**RESOLUTION HOLDING HEARING ON REQUEST FROM CITY OF DES MOINES FOR A
CERTIFICATE OF APPROPRIATENESS FOR WOODLAND CEMETARY AT 2019
WOODLAND AVENUE**

CITY OF DES MOINES LANDMARK REVIEW BOARD
STAFF REPORT AND RECOMMENDATION
Tuesday, September 6, 2022

CAHP-2022-000044

RETAINING WALL - 24th AVENUE

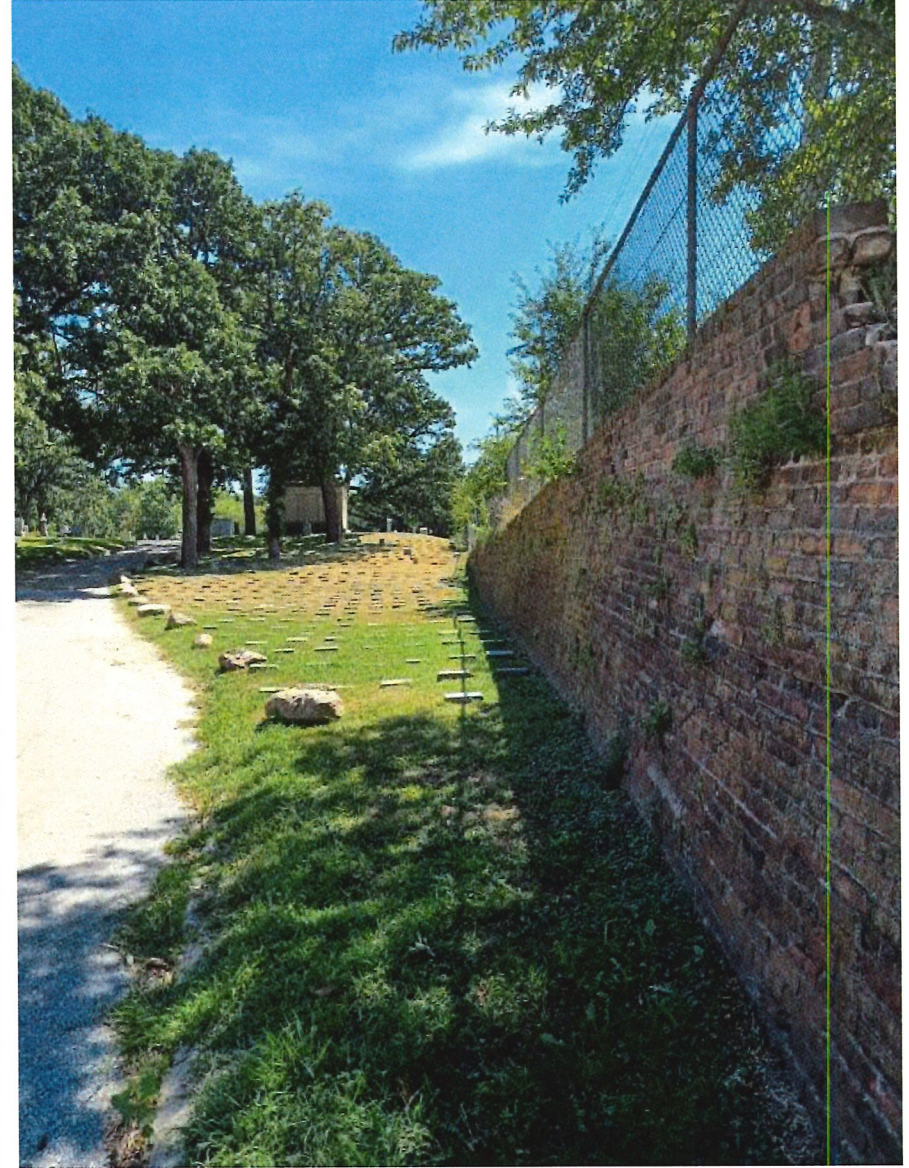
1. **Retaining Walls (Part A):** Many of the requests will feature noticeable changes to the overall character to the cemetery. Unfortunately, some of the changes cannot be avoided without eminent impact to other more significant features and spatial relationships within the cemetery, specifically existing gravesites. Staff finds that avoiding the impact to these gravesites exceeds the importance of the visual impacts of altering those features. In the case of the retaining walls, both planning and engineering staff have determined that the deterioration of these walls is to a point where replacement is the only viable option.

Engineering staff noted that replacement walls matching the height of these walls are typically constructed in one of two types: key/heel/toe (cast in place), or a segment block gravity wall. Both options have positive and negative impacts. Cast in place walls allow the possibility of introducing a brick façade to the walls, which will retain visual appearance satisfying standards 6 and 9. However, these walls require a wide foundation and "toe" that will greatly impact the existing roadways and gravesites near the walls, which would contradict standards 2 and 8. Additionally, they would impact public utilities and street trees in the right-of-way outside the cemetery.

Gravity walls do not require a large foundation or "toe", which allows installation without impact to surrounding features, satisfying standards 2 and 8, but does not allow the introduction of alternative visual façade materials. It may be possible to alter the visual look on one side of the gravity block to provide a more appropriate visual appearance, either by scoring, coloring, or texturing. Planning staff does not have a set alternative in mind to recommend but encourages advice and dialogue from board members and Engineering staff at the meeting.

1. Replacement retaining walls shall match the general scale and size of the historic walls.
2. Replacement retaining walls shall be constructed with materials that match the texture, size and color of the historic material to the extent possible. However, the characteristics of the selected material, such as the color, shall be representative of the selected material and not altered to appear brick-like if the product is not brick.
3. A cap element should be avoided to duplicate the simplicity of the historic walls.

Planning Staff Road Recommendations

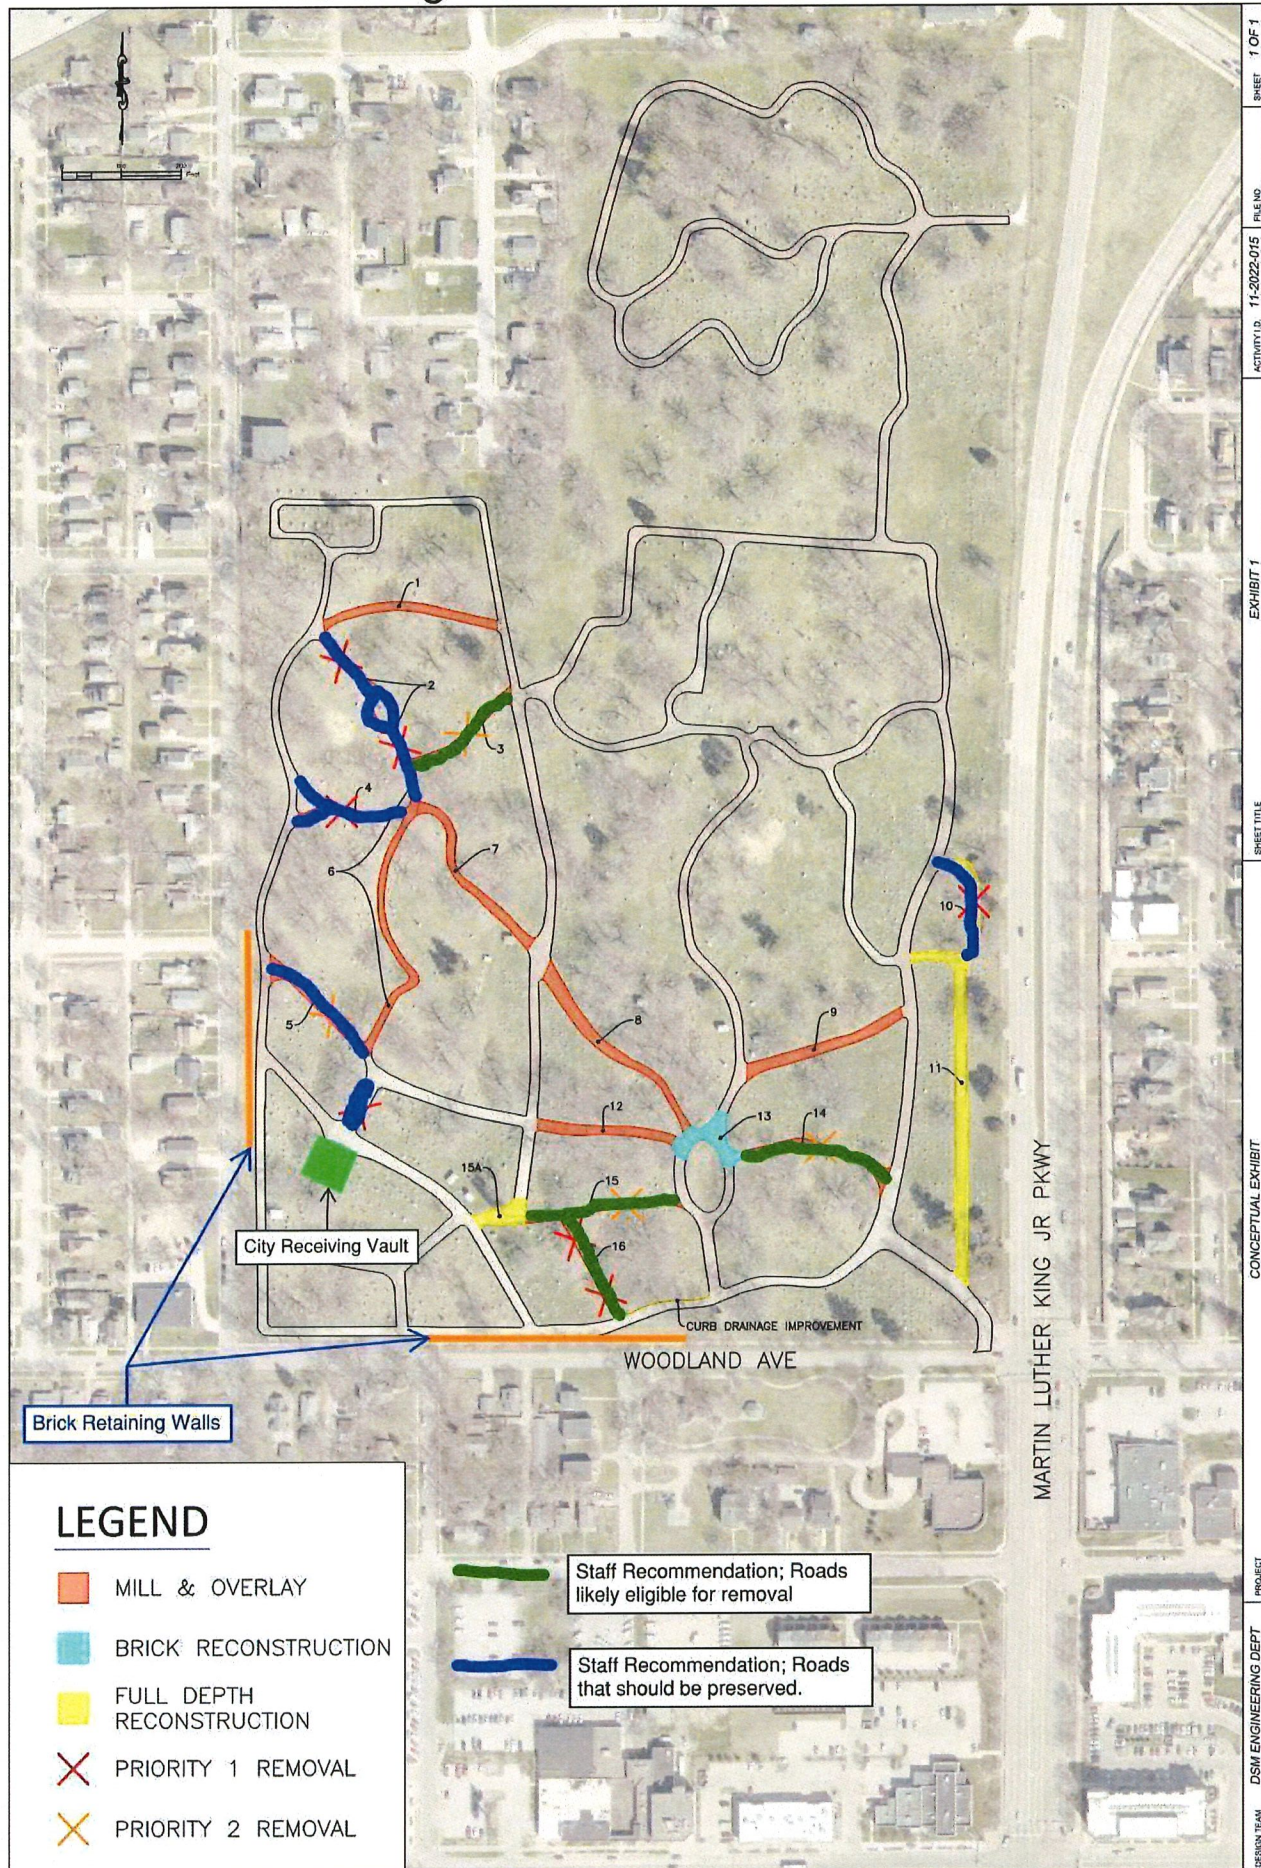
Planning staff finds that if a roadway has any of the above items, it is likely significant to the design and layout of Woodland Cemetery and should be preserved. Based on multiple visits to the site, and without the ability to truly verify the foundation of all roads, planning staff finds that of the roads proposed for potential removal, roads 2, 4, 5, 10, and the road leading to the city receiving vault outright feature evidence of visual cues or elements that create a spatial relationship with the cemetery and should be preserved. These cues include visual confirmation of curb and gutter, stairwells built into curbs or retaining walls along the road, family plots with walls and headstones facing that road, and monument layouts that create a symmetry with the road.

However, if the road does not feature any of the above items, or evidence can be provided to prove the road was installed at a later date and merely mimics the original design, it is possible that road may be eligible for removal. Based on a visit to the site and without the ability to verify the foundation of all of roads, it is likely that if any roads qualify for removal, it would be roads 3, 14, 15, and 16, as clear indication of curb and gutter systems, steps, headstone orientation, or other visual elements to provide spatial relationships were not present or appeared constructed at a later date.

- 1) The salvage of retaining wall bricks shall be explored to the satisfaction of the Planning & Urban Design Administrator.
- 2) Roads 2, 4, 5, 10, and the road leading to the City Receiving Vault shall be retained and reconstructed with brick pavers should coring identify underlying brick pavement.
- 3) Roads 3, 14, 15, and 16 shall be preserved should coring reveal brick pavement underneath the existing asphalt. They can be removed if coring does not reveal brick pavement.
- 4) The applicant shall review the coring results noted in conditions 2 and 3 with the Planning & Urban Design Administrator before proceeding with construction.
- 5) Review and approval of any conflicts with road rehabilitation, curb rehabilitation, and nearby features such as gravesites, trees, or other significant markers by Planning & Urban Design Administrator as needed.

ROAD 2 - RECOMMENDATION: TO BE PRESERVED

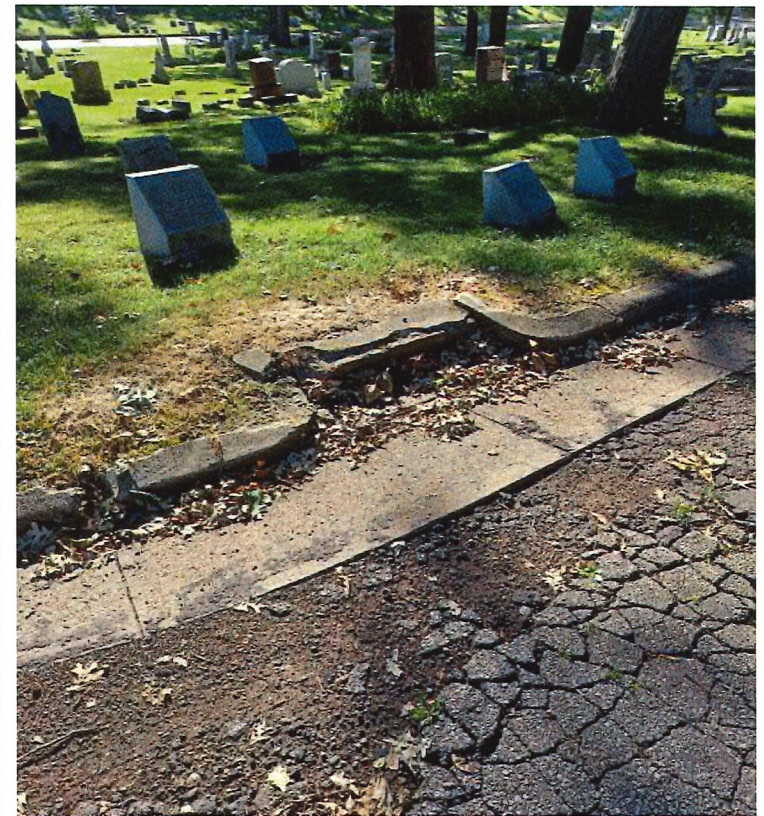
ROAD 2
RECOMMENDATON: TO BE PRESERVED

ROAD 5 - RECOMMENDATION: TO BE PRESERVED

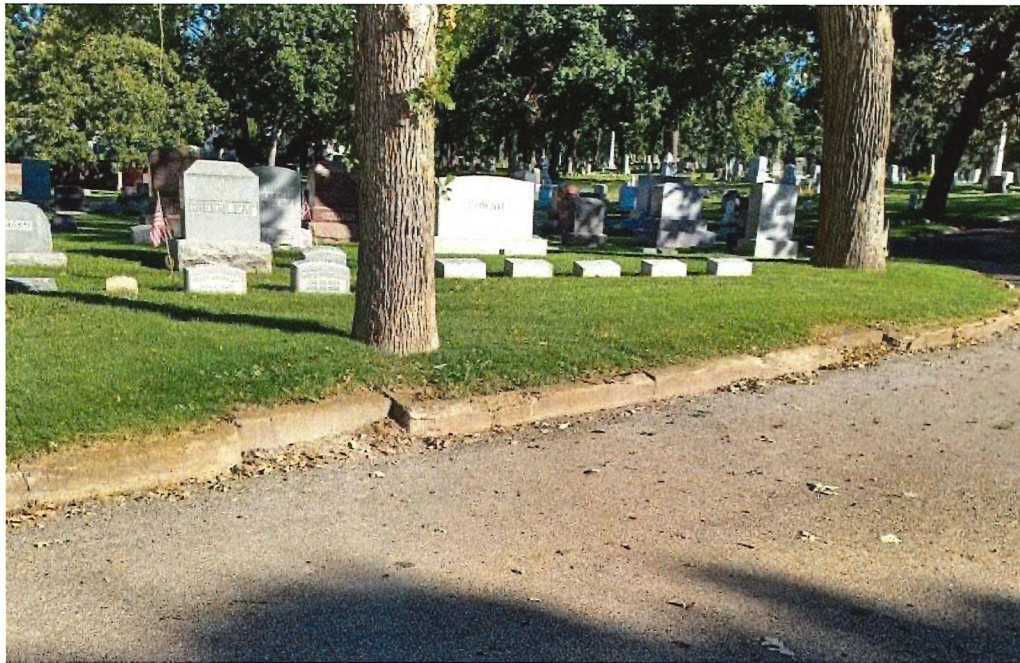
RECOMMENDATION: TO BE PRESERVED

VAULT ROAD - RECOMMENDATION: TO BE PRESERVED

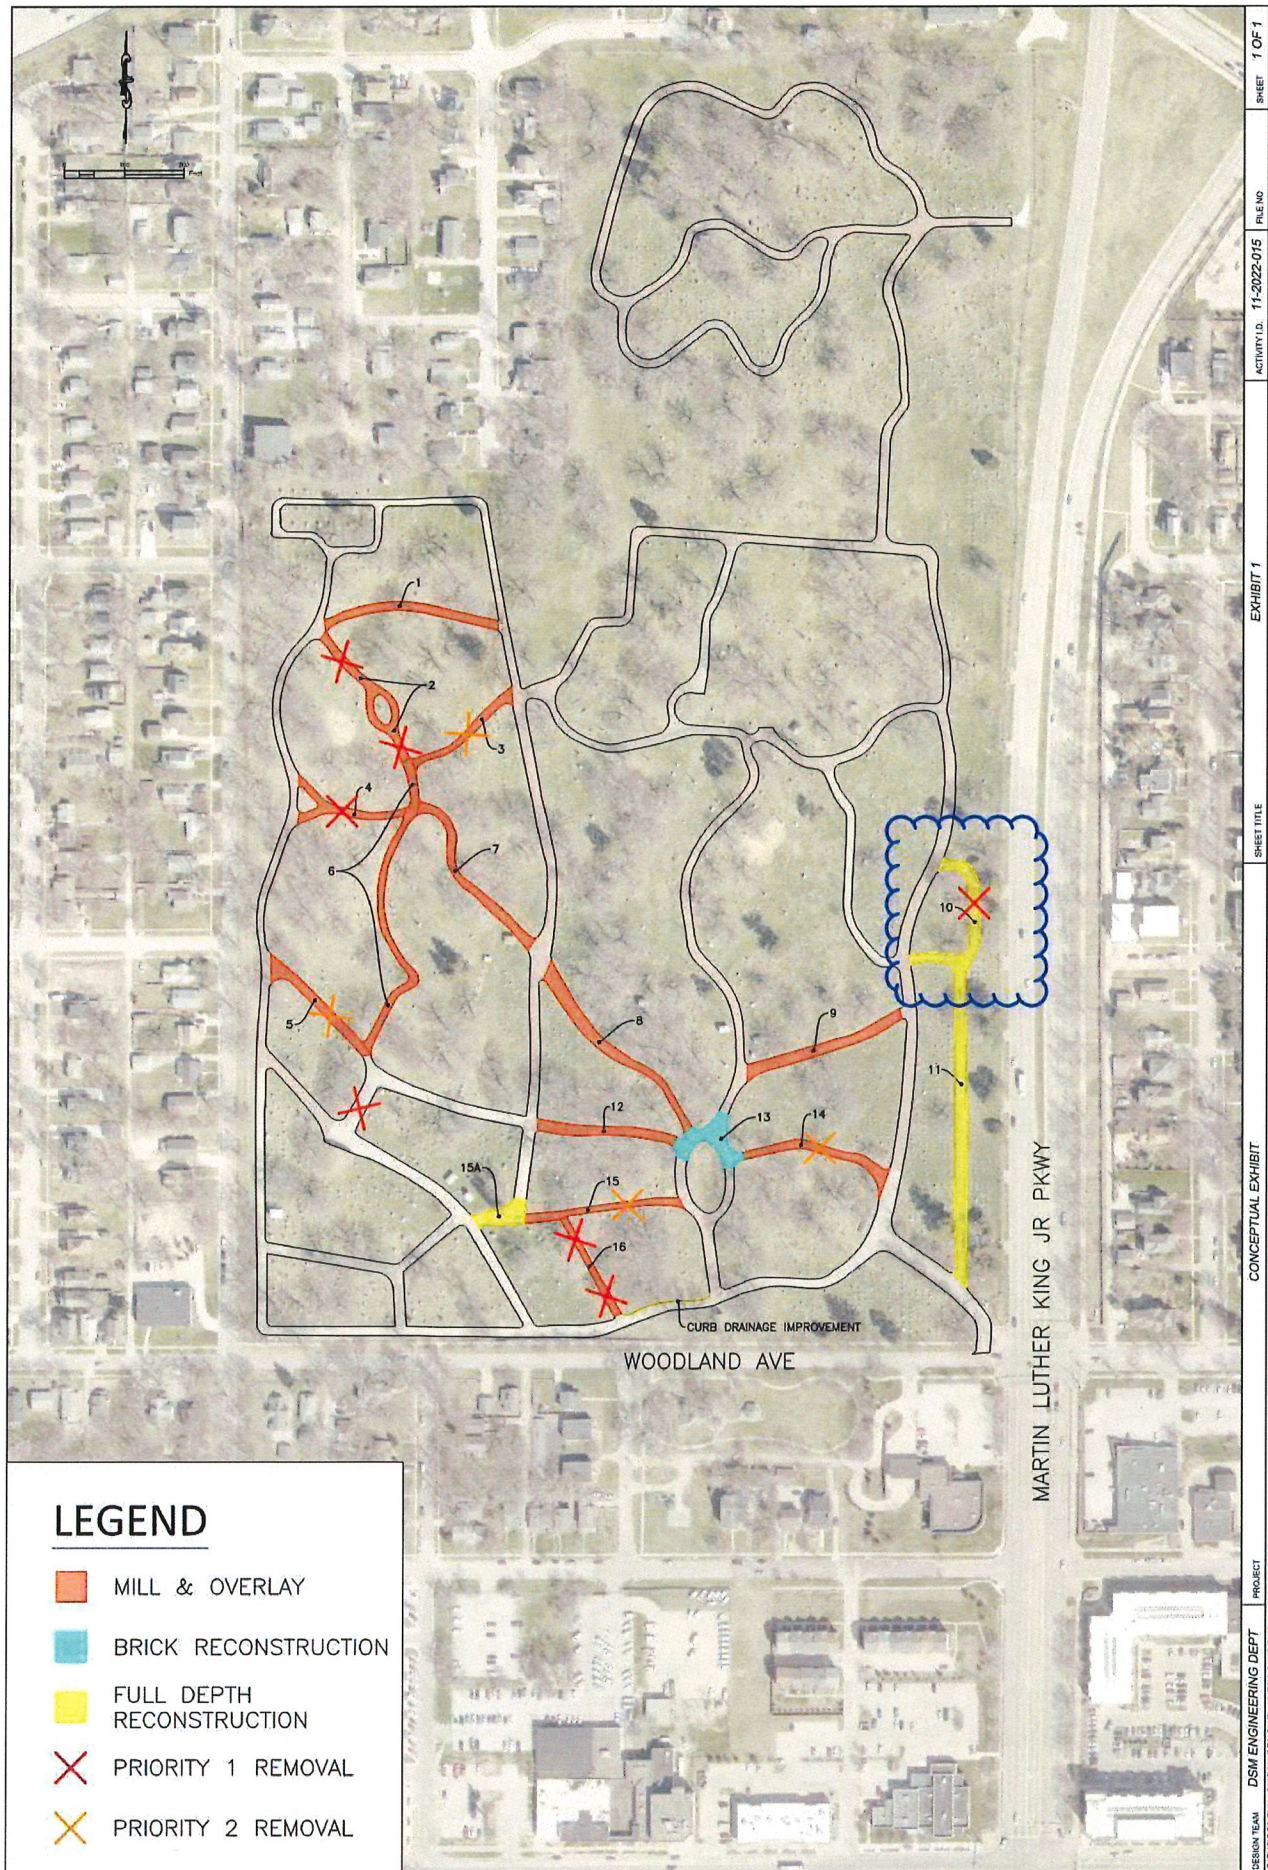
VAULT ROAD
RECOMMENDATION: TO BE PRESERVED

ROAD 10 - RECOMMENDATION: TO BE PRESERVED

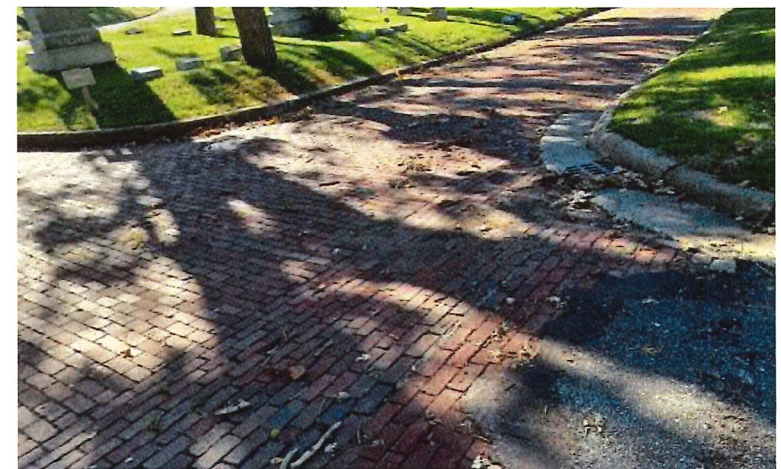
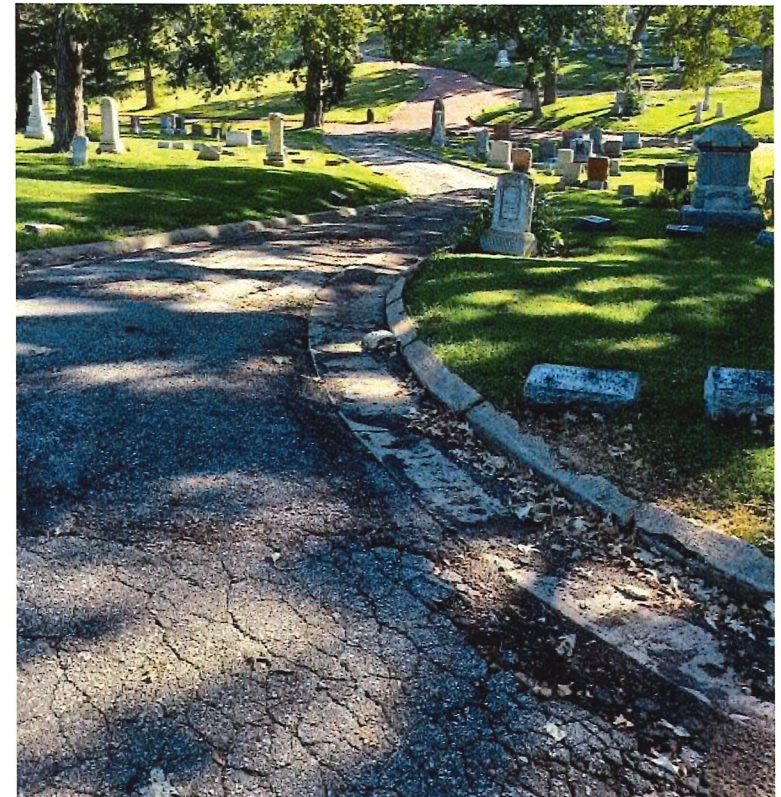
RECOMMENDATION: TO BE PRESERVED

ROAD 3 - RECOMMENDATION: ROAD LIKELY ELIGIBLE FOR REMOVAL

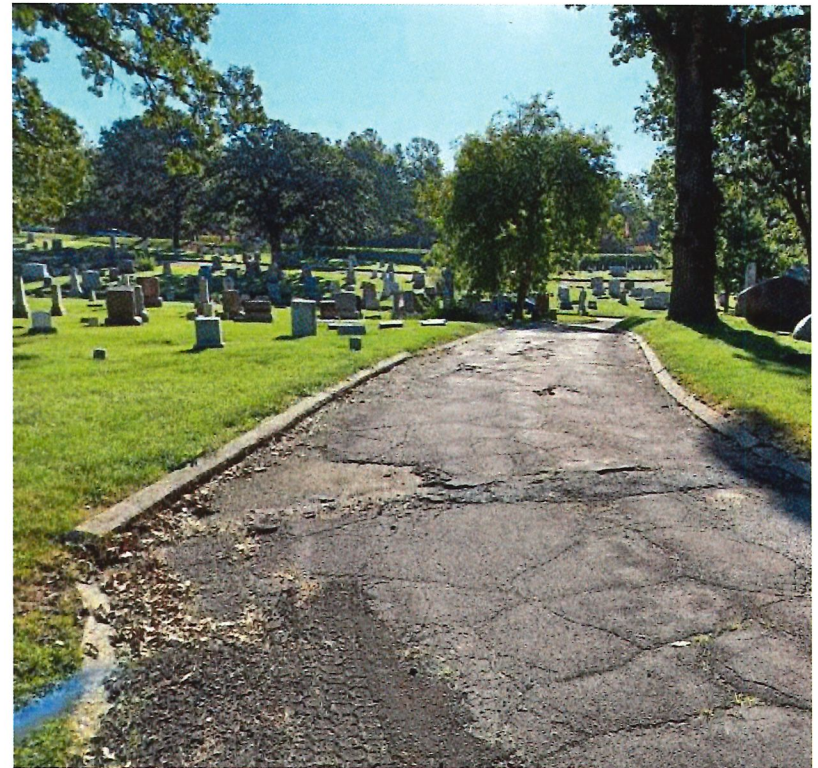
RECOMMENDATION: ROAD LIKELY ELIGIBLE FOR REMOVAL

ROADS 15 & 16 - RECOMMENDATION: ROAD LIKELY ELIGIBLE FOR REMOVAL

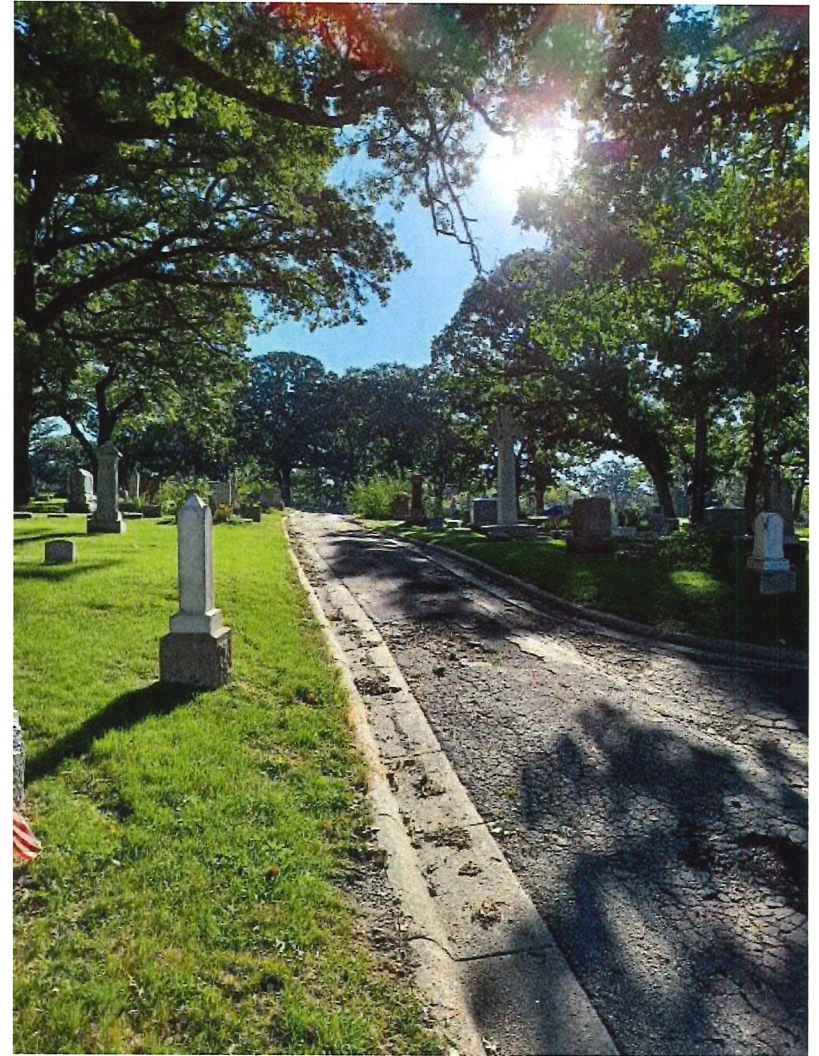
RECOMMENDATION: ROAD LIKELY ELIGIBLE FOR REMOVAL

RECOMMENDATION: ROAD LIKELY ELIGIBLE FOR REMOVAL

5. Road 16 can be removed if coring samples do not identify any brick paver material. The remaining roads shall be retained.
6. The applicant shall review the coring results noted in conditions 5 with the Planning & Urban Design Administrator before proceeding.
